SERVICE BULLETIN No. 7

SUBJECT: Fuel crossover supply line located forward of and under front seats.

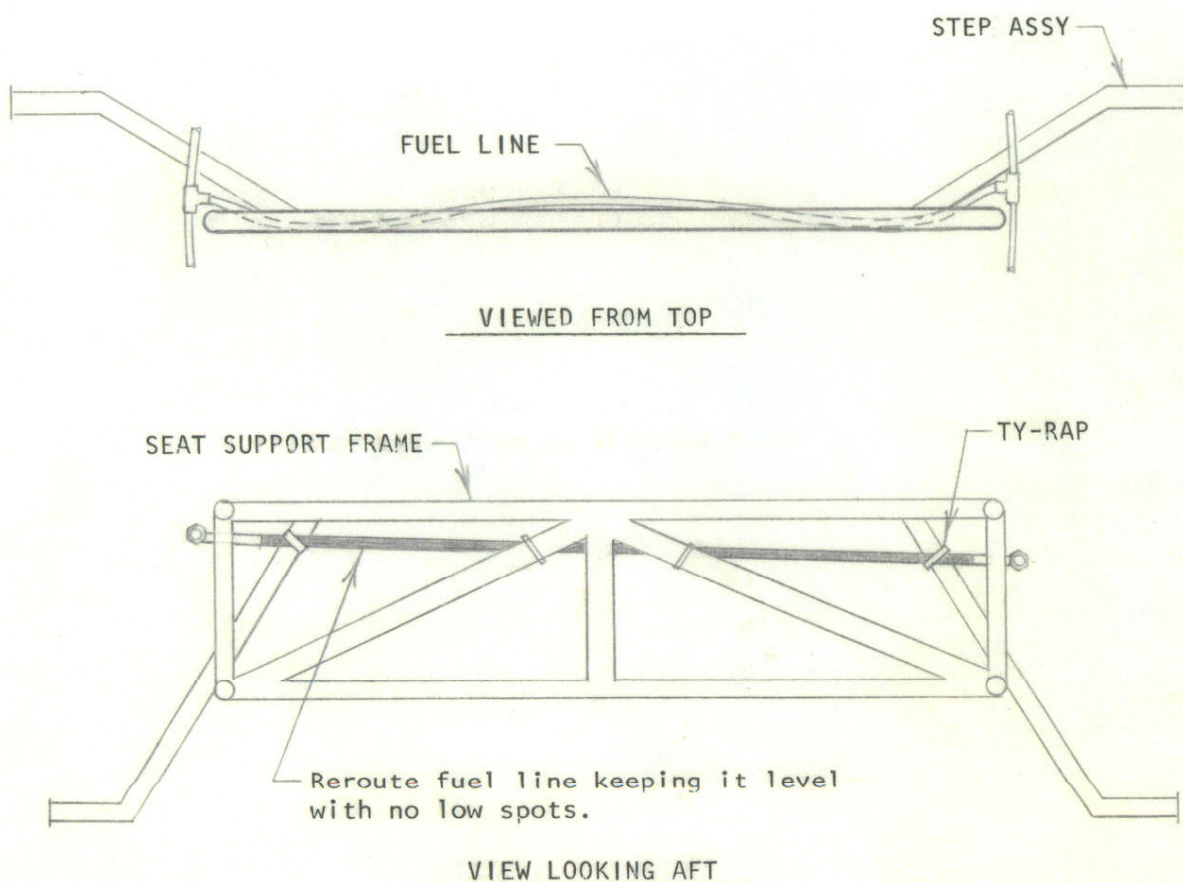
BACKGROUND: There is a possibility that the Flap Control Handle could be pulled against the fuel crossover supply line of those aircraft with front routed fuel line which may crush the line and thereby restrict fuel flow.

- (1) Examine forward area under front seats. If fuel crossover line is aft of the fuselage seat support frame, no further inspection or action is necessary.
- (2) If fuel crossover line is routed forward of seat support frame, inspect line for collapsed condition at area where the Flap Control Handle travels.
- (3) If fuel line is found to be collapsed, it must be replaced. A replacement line, complete with nuts, sleeves and anti-chafe sleeve can be obtained from Maule Air, Inc. for a service charge (call for price) or aluminum 3003-0 tubing to spec. WW-T-700/2 or 5052-0 tubing to spec. WW-T-700/4, 3/8" dia. x .035 may be used.
- (4) Upon inspection, if fuel line is in satisfactory condition, proceed to instructions for rerouting fuel line.

- (5) Reinstall line, routing forward of right step assembly tube, aft of the middle section of the seat support frame, then forward of left step assembly tube as shown in sketches below. Position anti-chafe sleeves as before and secure with Ty-raps. Assure fuel line is of sufficient distance from battery terminals and that line is covered with anti-chafe sleeve at battery location.
